**MONTGOMERY COUNTY HISTORIC PRESERVATION COMMISSION**  
**STAFF REPORT**

<b>Address:</b>	113 Elm Avenue, Takoma Park	<b>Meeting Date:</b>	5/27/2020
<b>Resource:</b>	Contributing Resource <b>Takoma Park Historic District</b>	<b>Report Date:</b>	5/20/2020
<b>Applicant:</b>	Brian and Catie Rowland (Eric Saul, Architect)	<b>Public Notice:</b>	5/13/2020
<b>Review:</b>	HAWP	<b>Tax Credit:</b>	No
<b>Case Number:</b>	37/03-20Z	<b>Staff:</b>	Dan Bruechert
<b>PROPOSAL:</b>	Partial demolition, new roof, rear addition, and other alterations.

Figure 2: 1927 Sanborn Fire Insurance Map showing the subject property in its original configuration.

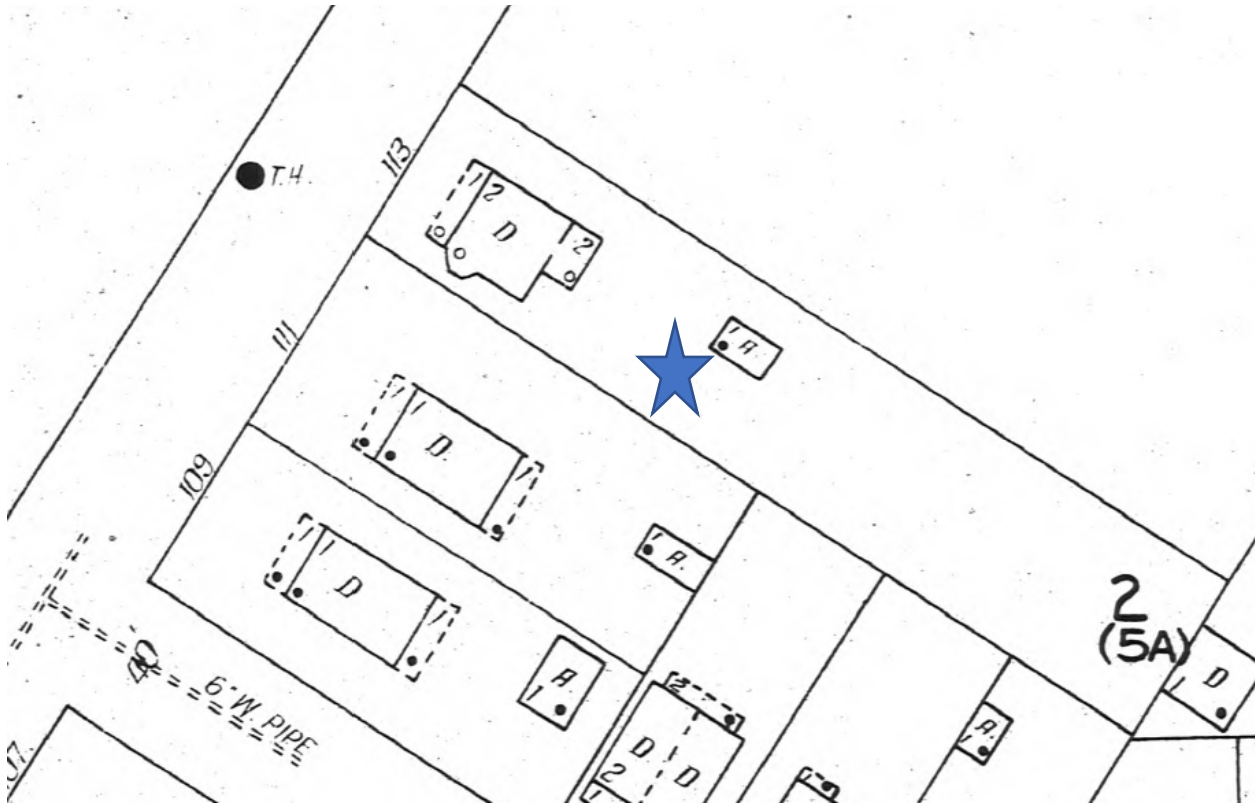
As shown in the Sanborn Maps, above, the rear of the house has been expanded from its original form. The exterior wall treatments on the rear addition match the house with stucco on the ground floor and siding on the second floor. The windows in the rear are a mix of sash (both two-over-two and six-over-six) and casements. The rear door is a half-lite wood door. A rear stoop was removed, but its design and materials are unknown.

2 PROPOSED ROOF PLAN  
A1.2 1/4" = 1'-0"

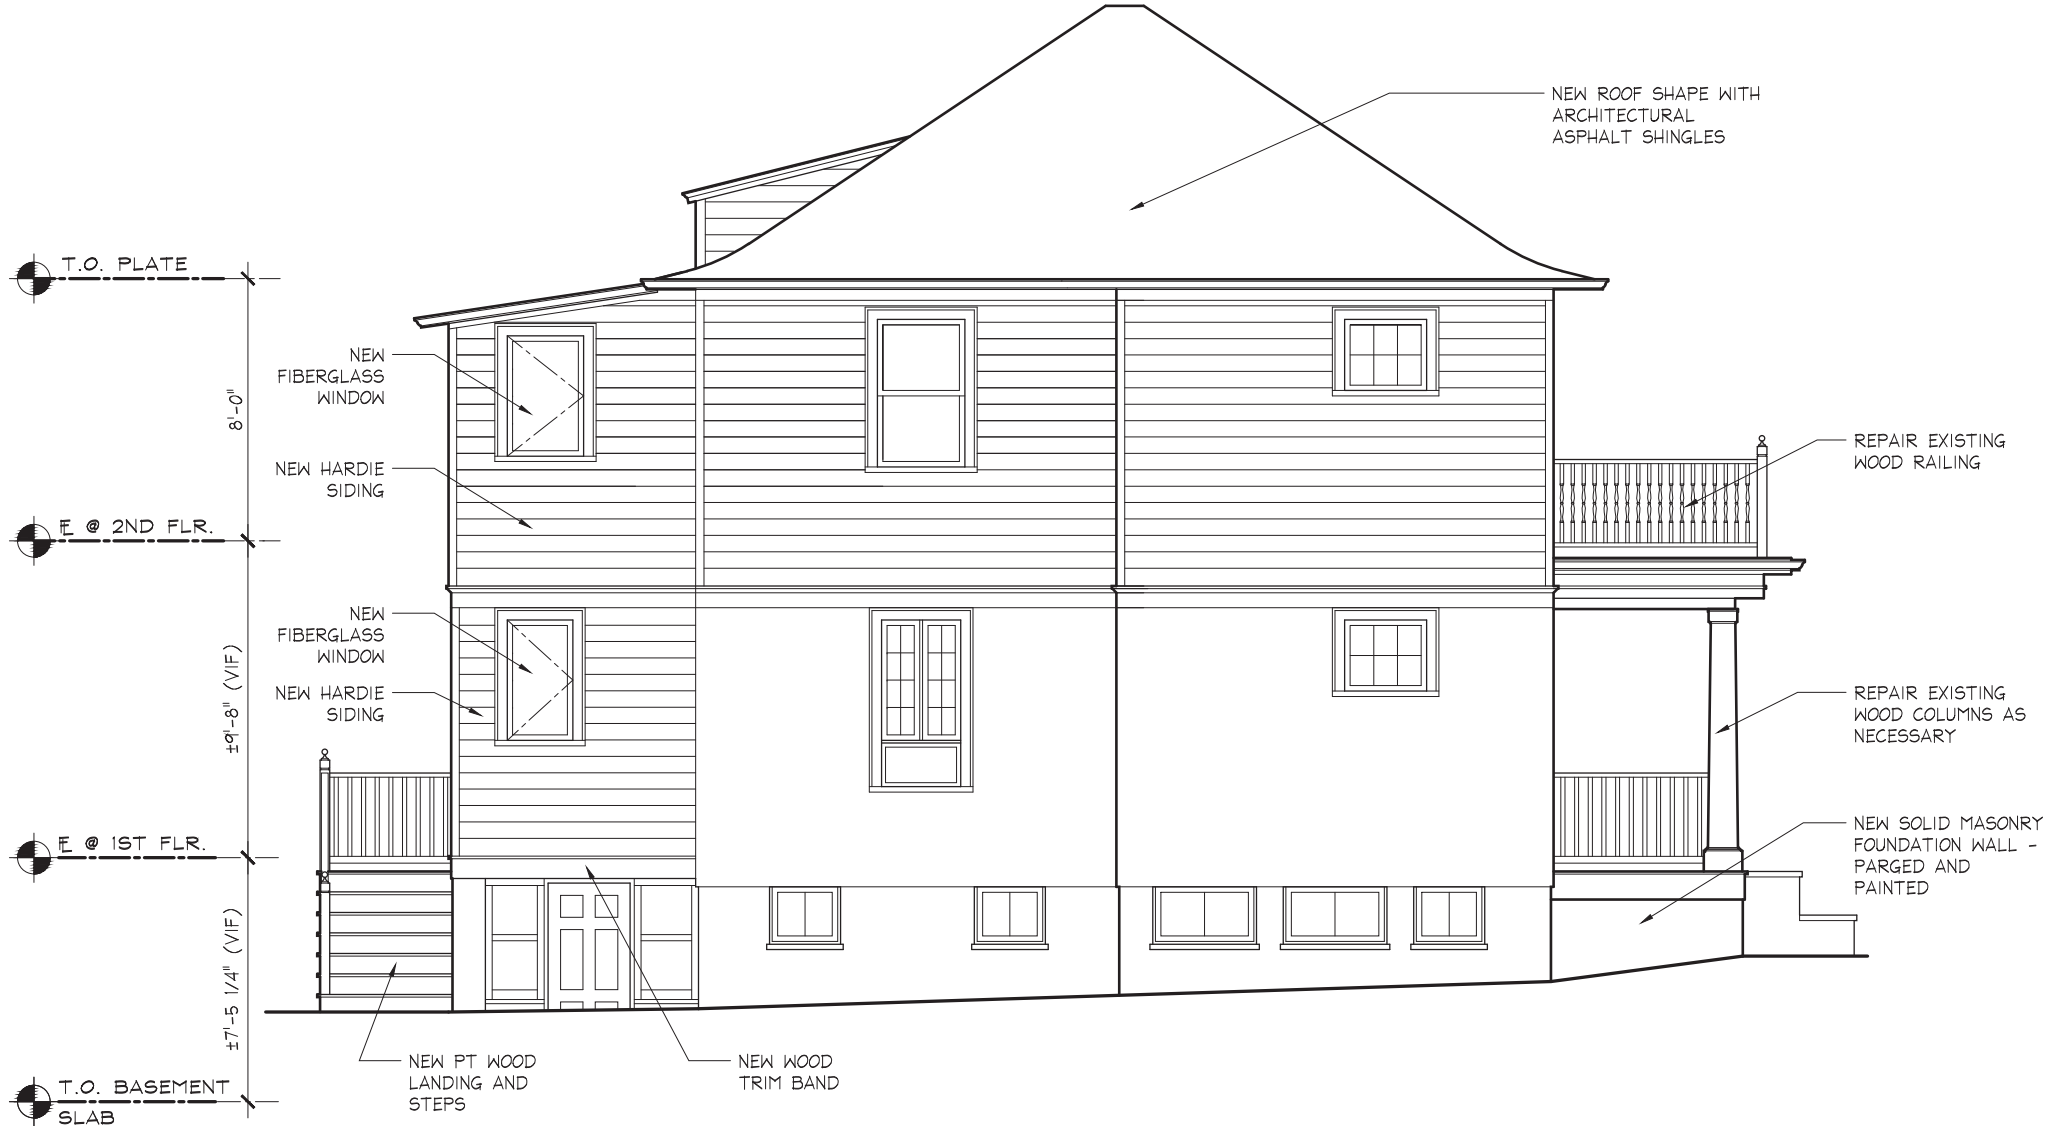
The applicant proposes to remove the existing roof and construct a pyramidal roof with a central peak. The new roof design will retain the distinctive flared eaves. The rear shed dormer will be retained and a window is proposed in place of the existing attic vent.

The roof reconfiguration will somewhat alter the appearance of the house when viewed from the public right-of-way. However, the current roof configuration and its inability to effectively control water continue to cause damage to the house. Staff finds that the long-term survival of the historic house appears to be better served by allowing the change (per 24A-8(b)(3)). Staff finds that converting the vent to a window is an acceptable alteration as this change is at the back and appears to match the size of the existing vent. Additionally, in the Takoma Park Historic District window replacements on the rear or new construction have frequently accepted aluminum-clad wood windows as an acceptable substitute for traditional wood windows. Staff recommends the HPC approve the proposed roof replacement and dormer alteration.

1  
A2 PROPOSED FRONT ELEVATION  
1/4" = 1'-0"

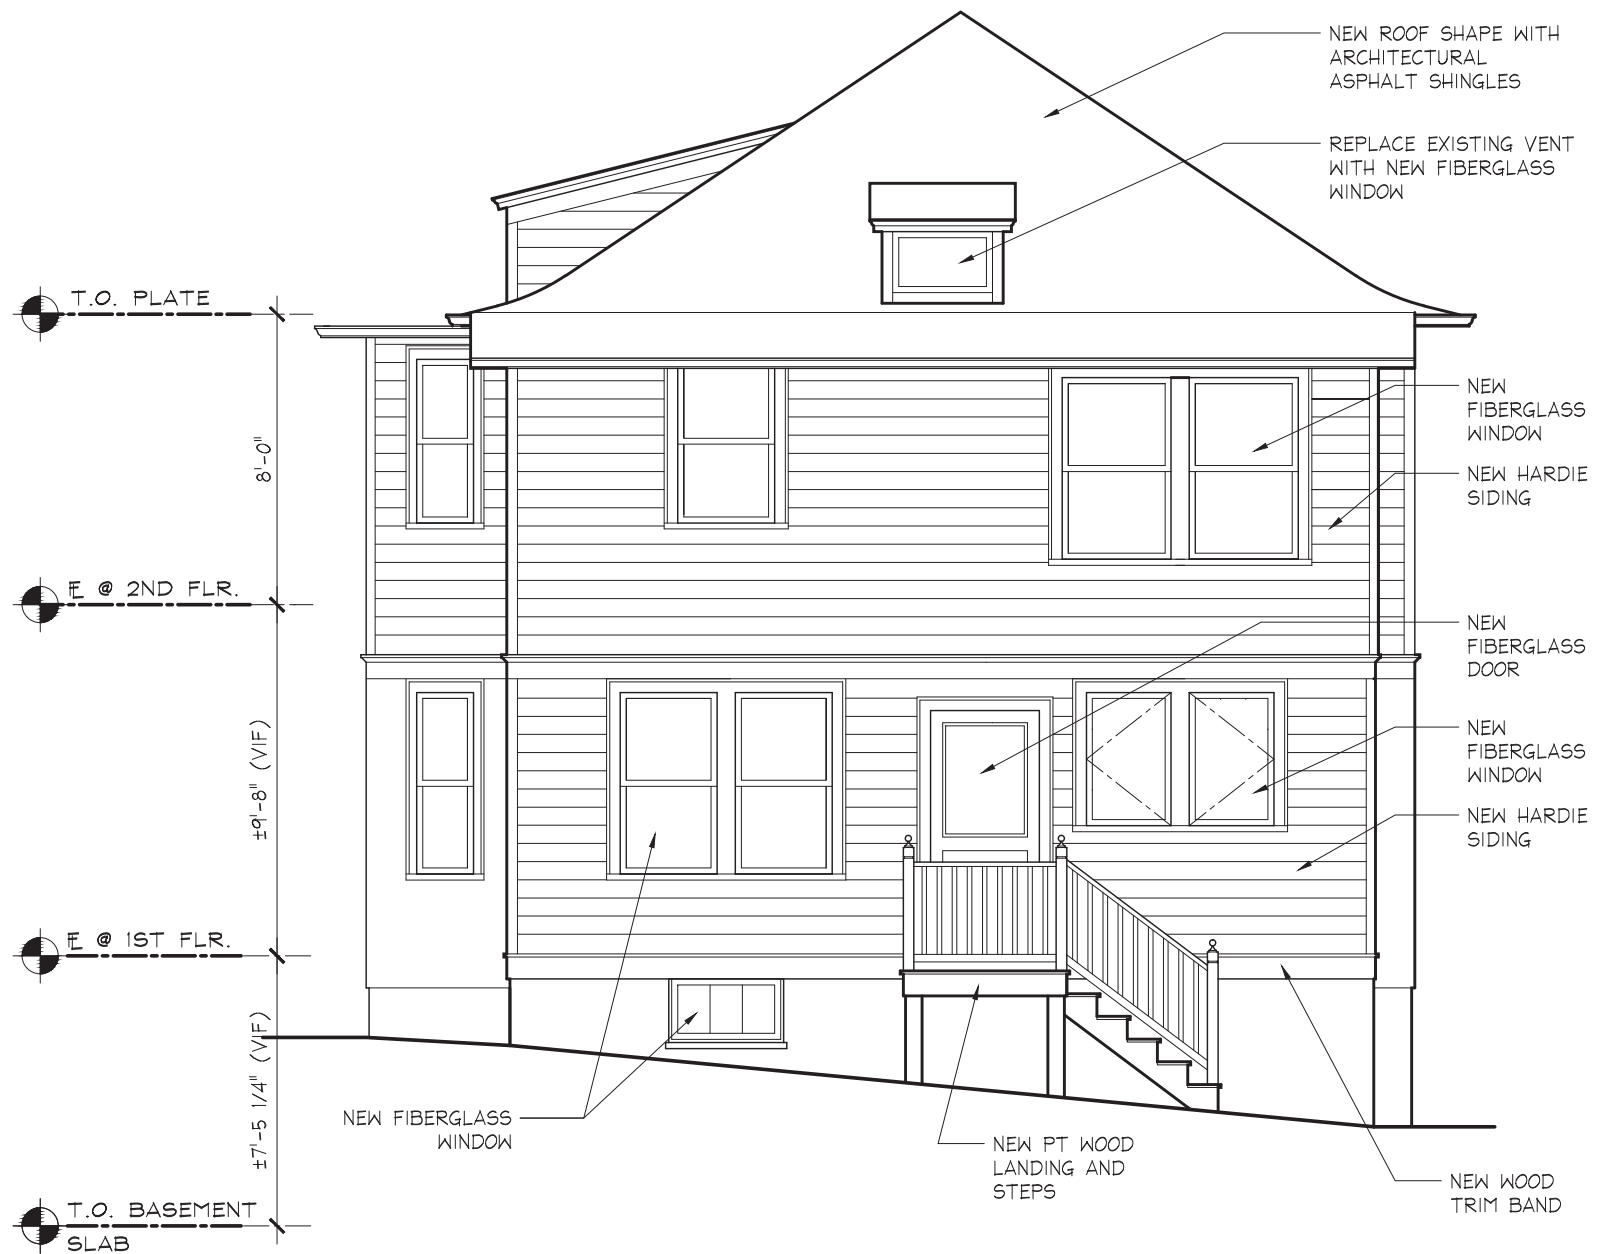
The current front porch is a wood porch constructed on brick piers. The applicant proposes to excavate a storage area under the front porch and construct a new parged solid concrete foundation under the porch. No other alterations are proposed for the front porch.

While much of the foundation will be screened with vegetation, evaluation of the proposal is to be considered in the absence of vegetation.

Staff finds that a parged and painted porch foundation will not significantly alter the character of the house. The HPC concurred with this position and voiced support for this change. Staff recommends approval of the front porch alterations under the *Design Guidelines* and 24A-8(b)(2) and 24A-8(d).

2 PROPOSED REAR ELEVATION  
A2 1/4" = 1'-0"

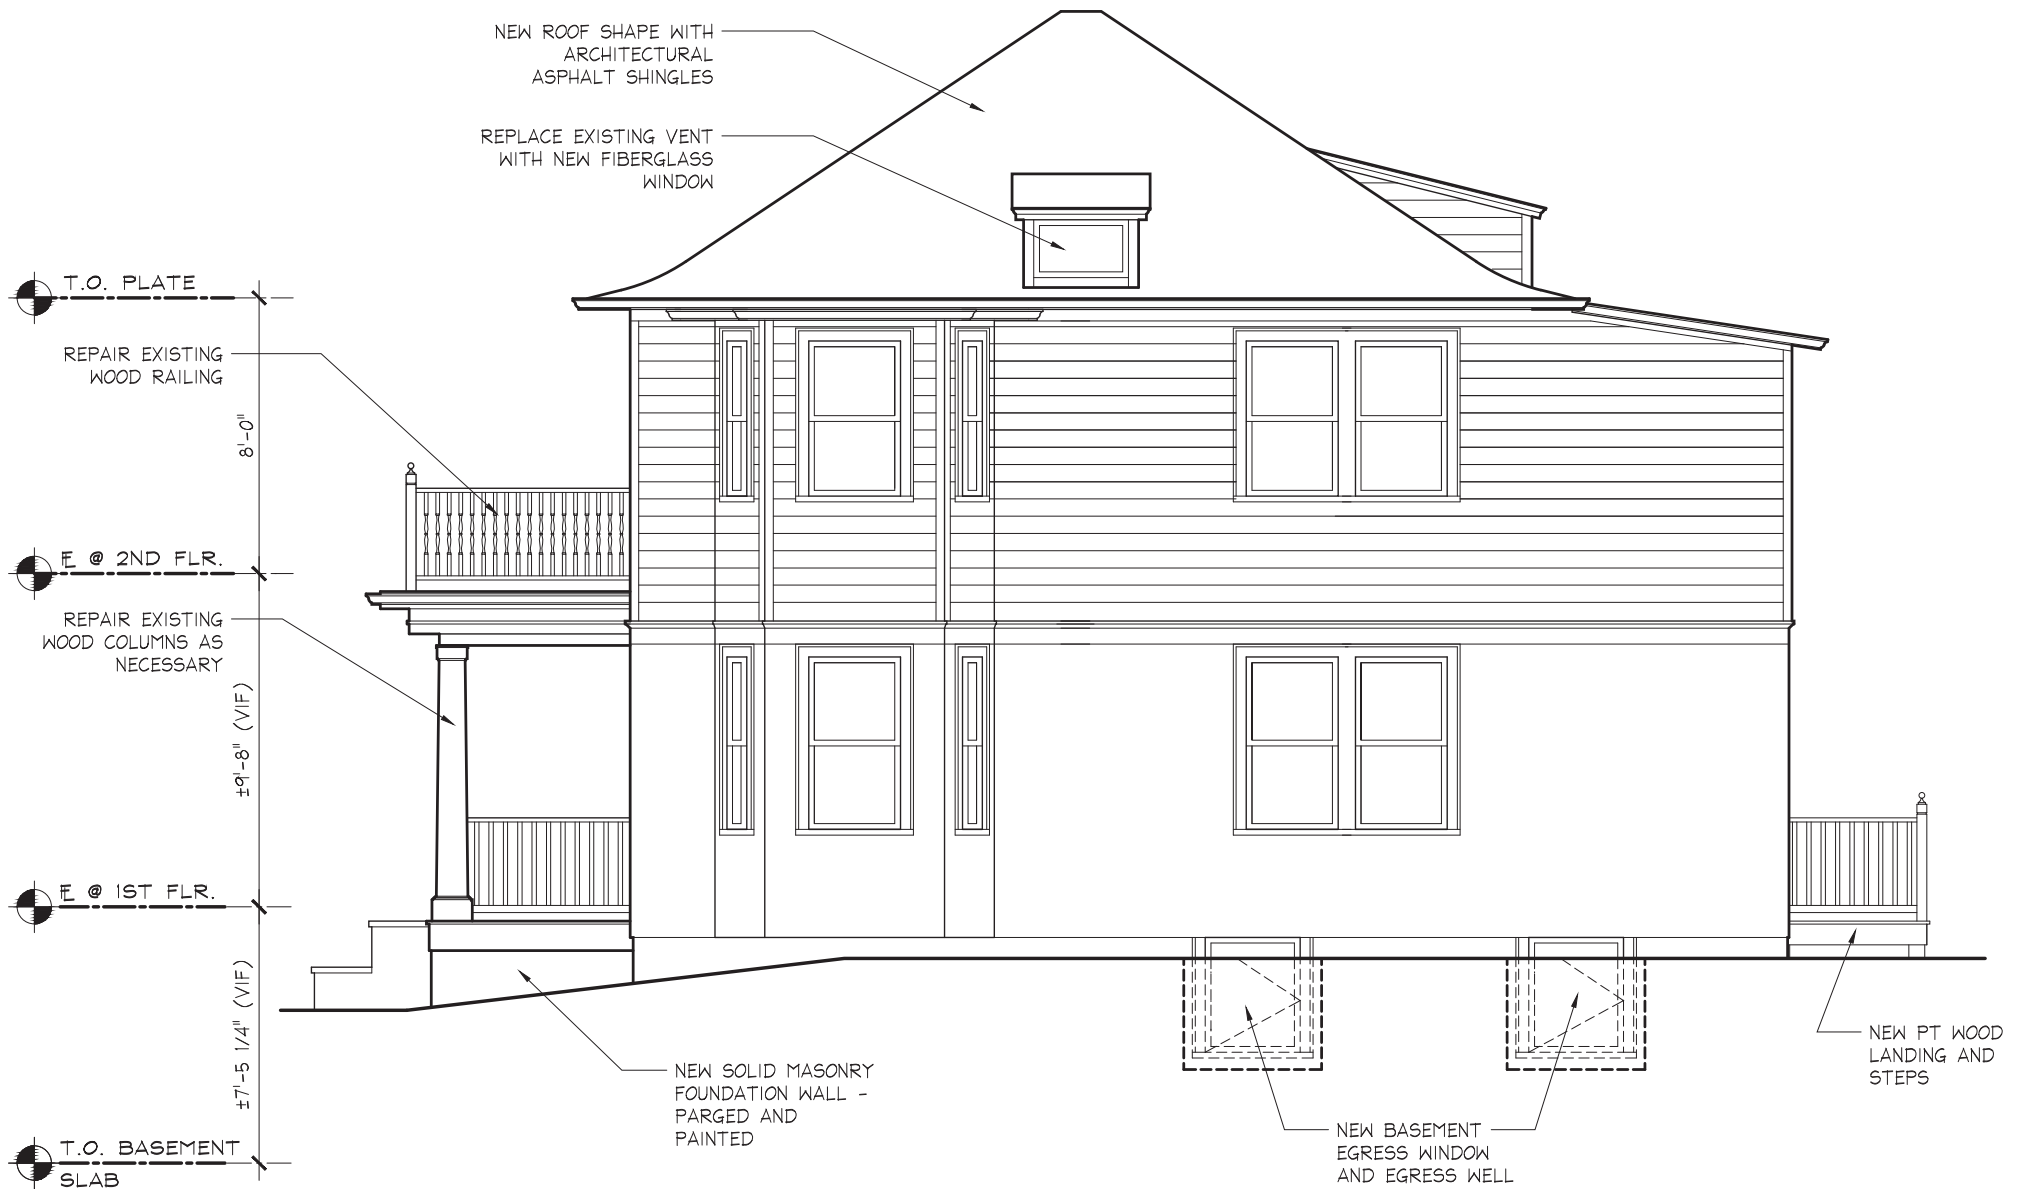
The applicant proposes altering the fenestration of the rear addition to accommodate a reconfiguration of interior spaces. The door will be moved closer to the center of the elevation with a new set of wood stairs. On the first floor, the applicant proposes a pair of sash windows to the left of the door and a pair of casement windows to the right of the door. On the second floor, the applicant proposes installing a single one-over-one sash window on the left of the elevation and a pair of one-over-one sash windows on the right. On the left (east) elevation, the applicant proposes installing a casement window on each floor. All of the new windows proposed are Andersen 400 Series aluminum-clad wood windows. The applicant proposes installing a new half-lite door on the rear. The proposed door (specifications attached) has a fiberglass exterior with a smooth paintable surface. While traditional materials are preferred for replacement windows and doors, more leniency is given in new construction and areas that are not visible from the public right-of-way. Staff finds that an aluminum-clad window on the rear and fiberglass door is acceptable under the Takoma Park Historic District *Design Guidelines* and 24A-8(d).

The last change proposed for the rear addition is re-siding both floors of the rear of the house in fiber cement clapboard siding in a reveal that matches the existing second floor.

Staff finds that proposed fenestration reconfiguration is appropriate overall. The rear elevation has been altered from its historic configuration, so the proposed work will not significantly alter historic features. Additionally, most of the proposed work is on the rear, and will not be visible from the public right-of-way within the district, so evaluations of these changes should be judged leniently (24A-8(d)) and *Design Guidelines*.
